CITY OF BELTON

Planning & Zoning Commission Meeting Tuesday, April 17, 2018 - 5:30 p.m. Wright Room, Harris Community Center 401 N. Alexander, Belton, Texas

Applicant: TREY GALLAWAY / TURLEY ASSOCIATES Date Submitted: 03-15-18 2nd Submittal: 04-04-18 3rd Submittal: 04-11-18 Project: SOUTH WALL ESTATES - Preliminary Location: 6.749 ACRES – 2504 South Wall Street

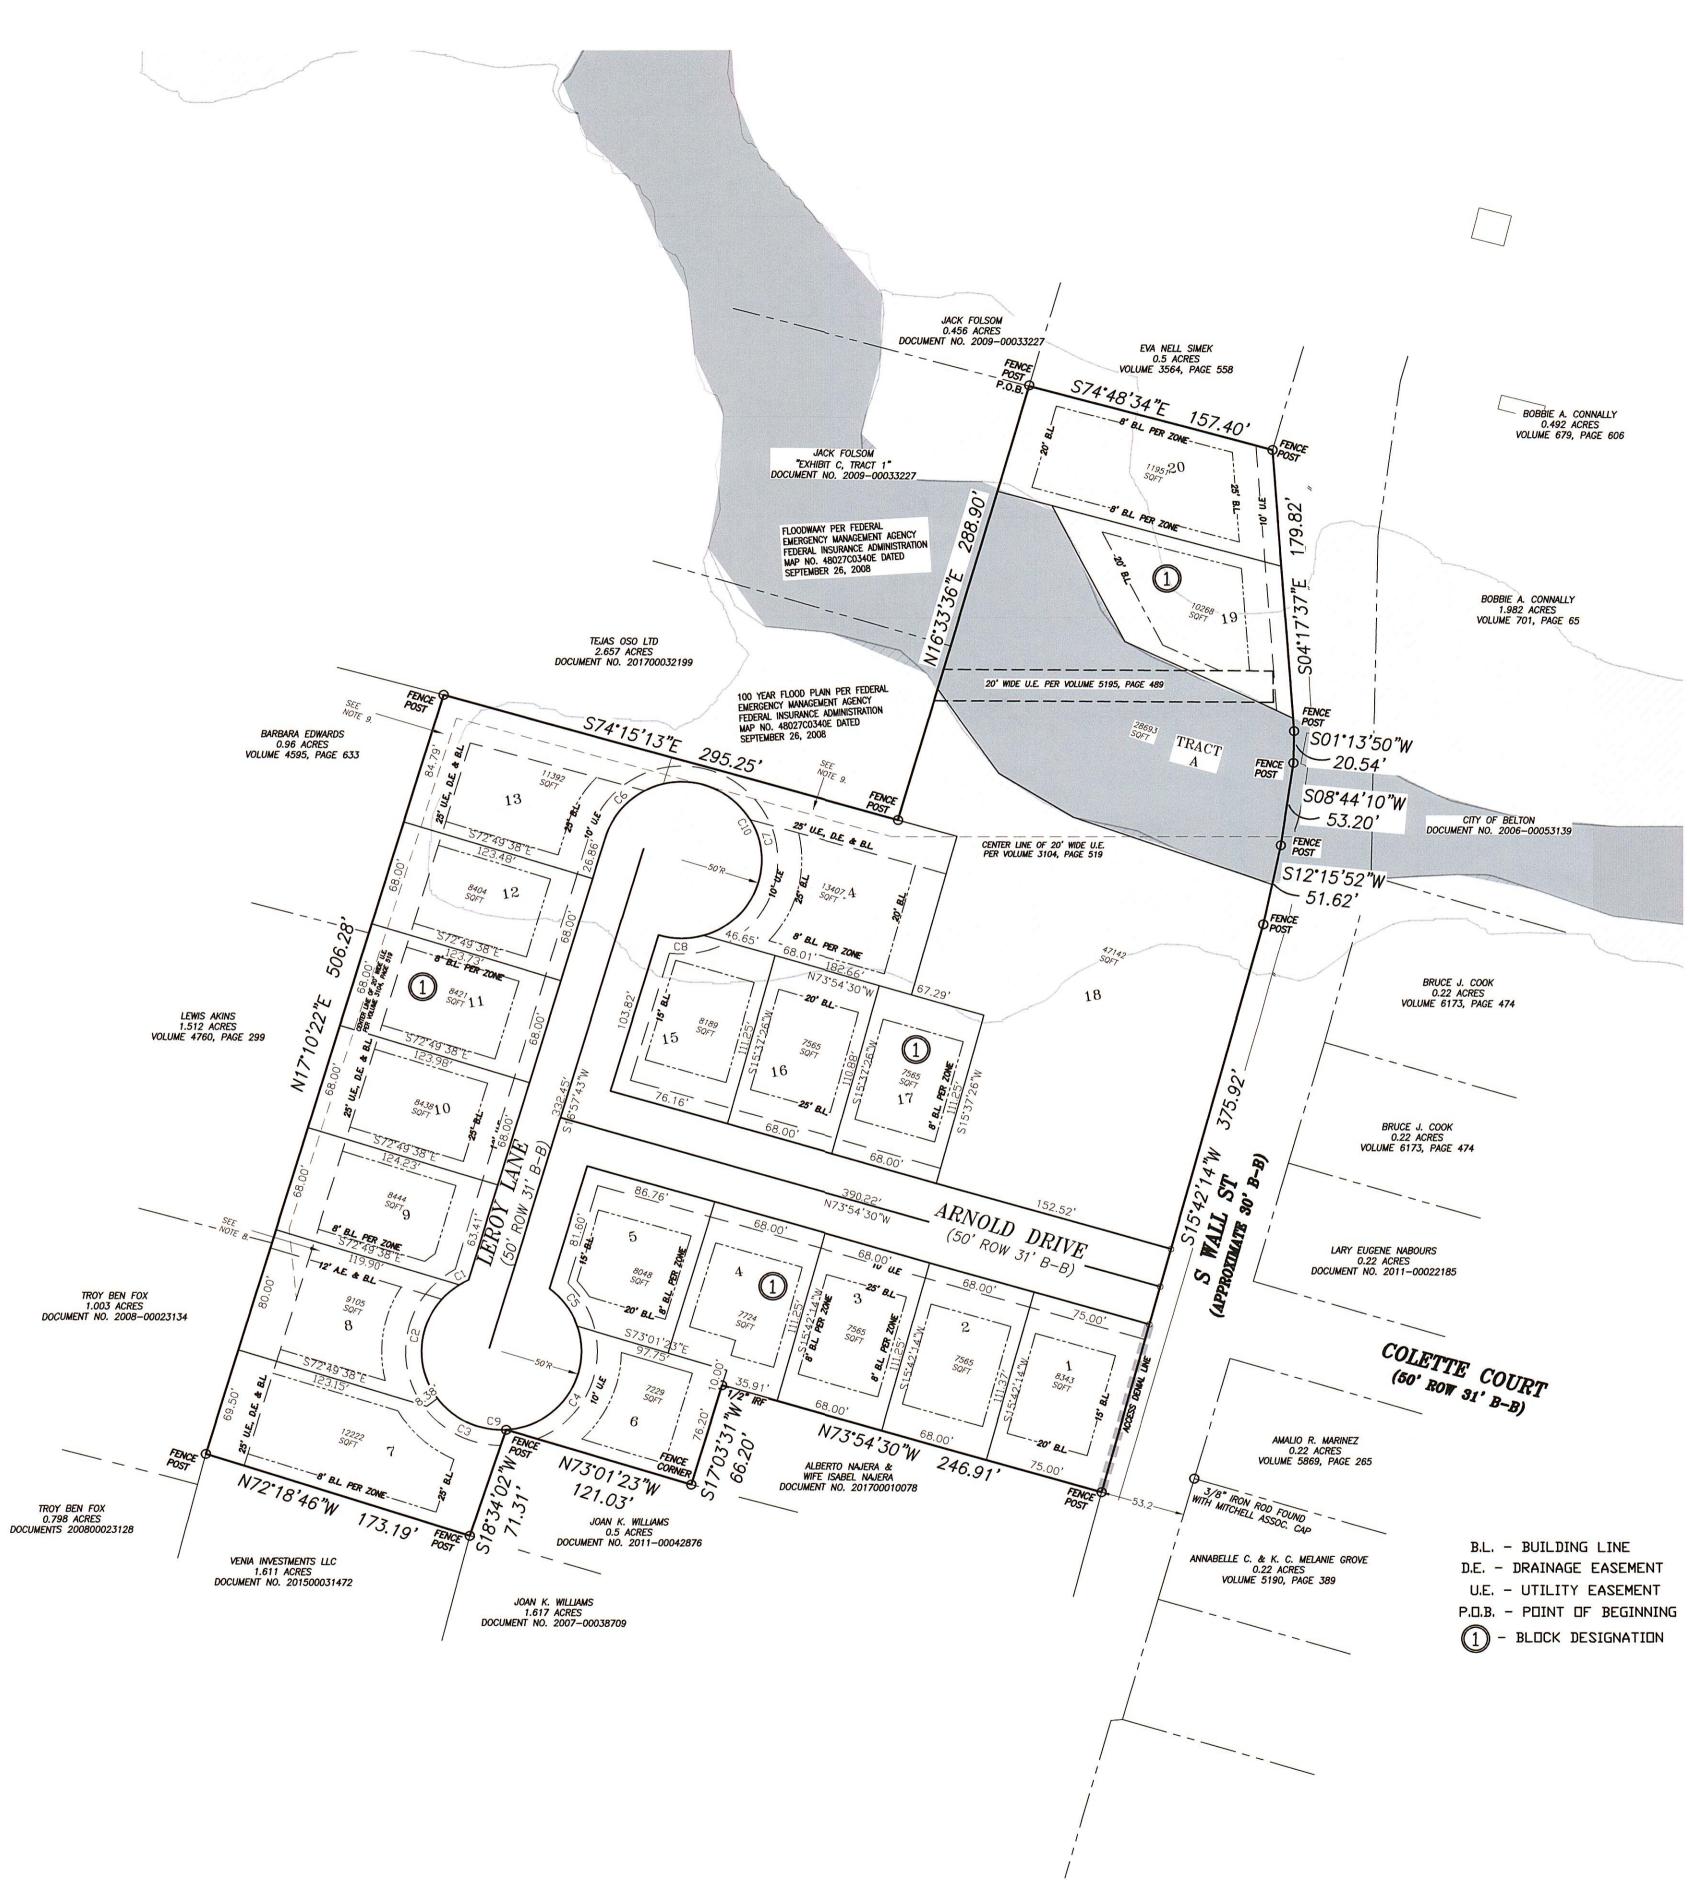
- 1. Move the light from Lot 16 to the corner of Arnold and Leroy.
- 2. Are water valves shown at Lot 8/9 and Lot 13/14? The symbol is different than the legend.
- 3. Minimum Finished Floor Elevations need to be defined for Lots 12-20 inasmuch as portions of each of these lots are in the floodplain.
- 4. Based on our meeting with Ms. Ryken on April 3rd, Turley will evaluate the effects of this development in relation to the overall watershed, which they have studied a large portion of west of I-35. It was understood that this additional study would occur during the construction plan development phase and not be a hold up for consideration of preliminary plat approval.

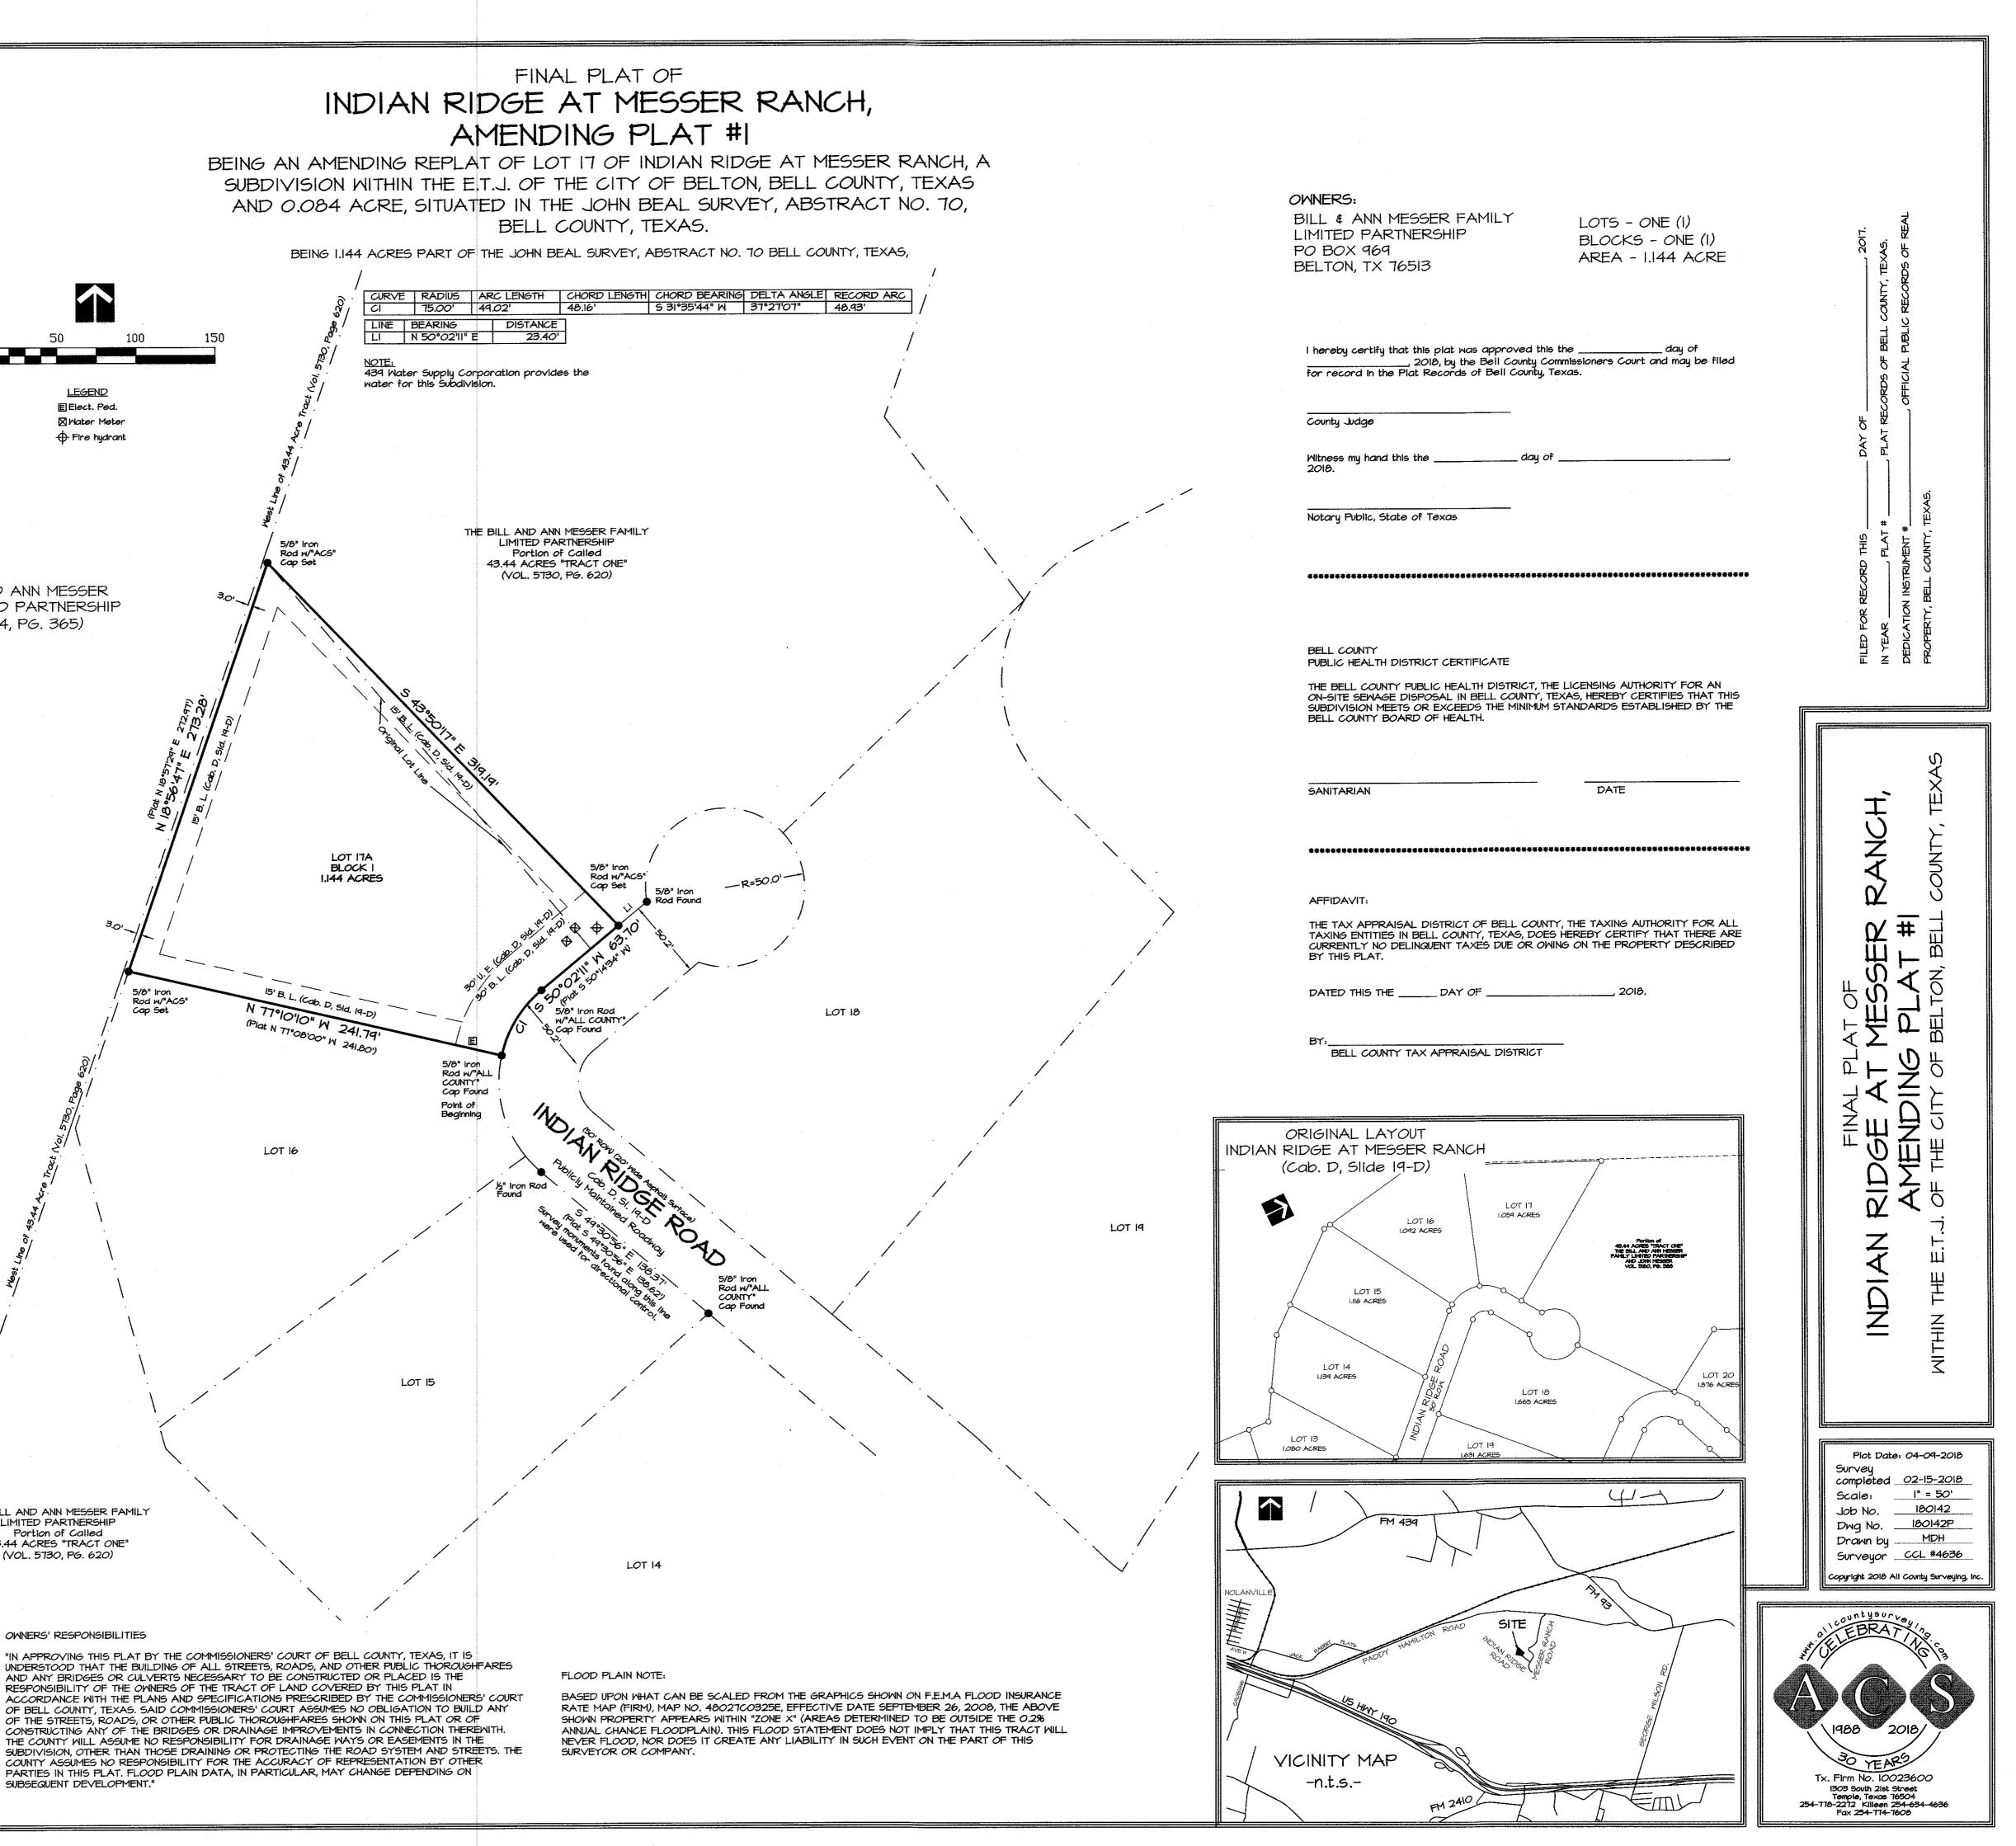
- 1. Replace the signature blocks for administrative approval with the PZC/CC approval signature blocks.
- 2. Submit an official letter from 439 WSC stating this subdivision is provided with domestic service and flows will not support the minimum 1,000 gpm required by the Belton Fire Code.
- 3. Submit a utility sheet showing existing water line and size, hydrant locations, and any other utilities on the property.
- 4. Submit a revised letter from Bell County Health Department correcting the WSC from Dog Ridge to 439 WSC.
- 5. Submit a letter from Clearwater UWCD stating they have evaluated this site, noting the location of residential wells.
